# Service Bulletin

BKSB-1003A  
Issue Date 08-15-01

## UPDATE TO BKSB-1003. ISSUED 8-2000

**Issue:** Possible GPH communication failure.

Figure 2

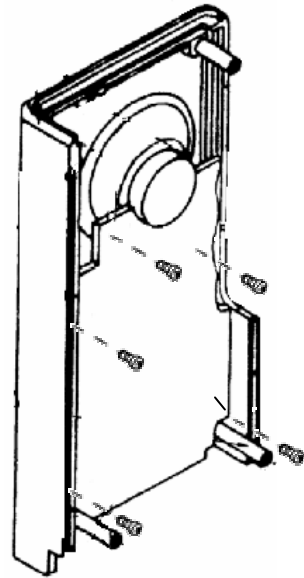
1. Turn off radio and remove battery.
2. Disassemble radio.
  - a) Remove 4 screws from rear cover of radio.
  - b) Pull front radio assembly straight out.
  - c) Gently slide white connector clip up and disconnect flex circuit from options board.
  - d) Remove five screws from options board and disconnect from keyboard. (Fig.2)
3. On the keyboard, check the markings on Q3 and Q4.

Figure 3

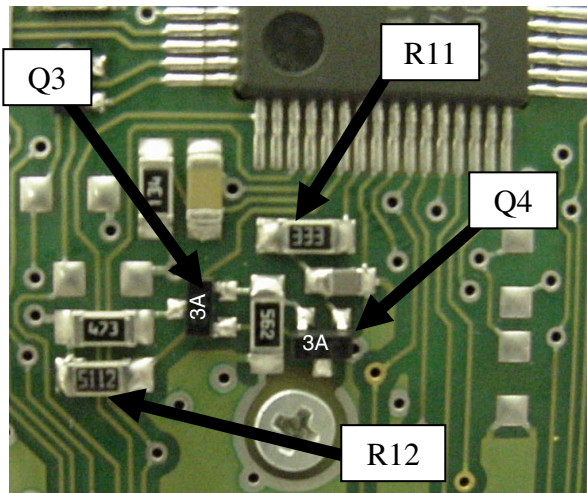
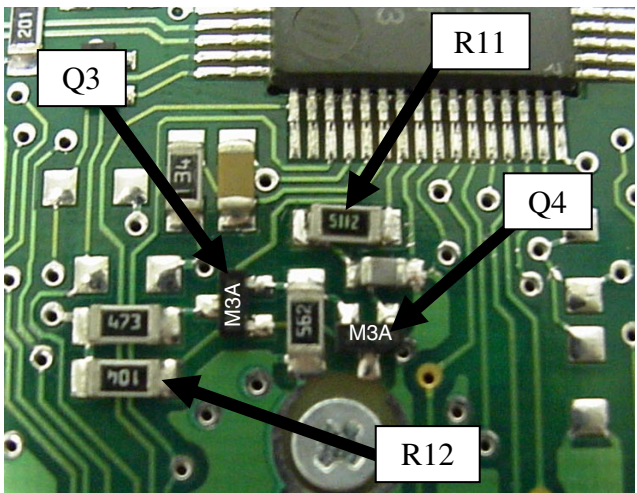
Due to a change in supplier of Q3 and Q4 on GPH Alphanumeric keyboards, R11 and R12 of the keyboard must be specific values to match the manufacturer. If R11 and R12 are the incorrect value the GPH may realize a communication failure between the keyboard and the core processor. This condition could result in the GPH "locking up". By cycling power the GPH will resume normal operation.

Should a radio display this condition check the value of R11 and R12 as detailed in Figure 3 and perform the following procedure as required.

**If the markings on Q3 and Q4 are 3A**

R11 should be marked 333  
R12 should be marked 5112

**If the markings on Q3 and Q4 are M3A**

R11 should be marked 5112  
R12 should be marked 104

4. Replace R11 and R12 as necessary.

R11 - Surface Mount 33K Ohm Resistor (PN 4718-50237-398)  
R12 - Surface Mount 51.1K Ohm Resistor (PN 4718-50317-198)

R11 - Surface Mount 51.1K Ohm Resistor (PN 4718-50317-198)  
R12 - Surface Mount 100K Ohm Resistor (PN 4718-50237-322)
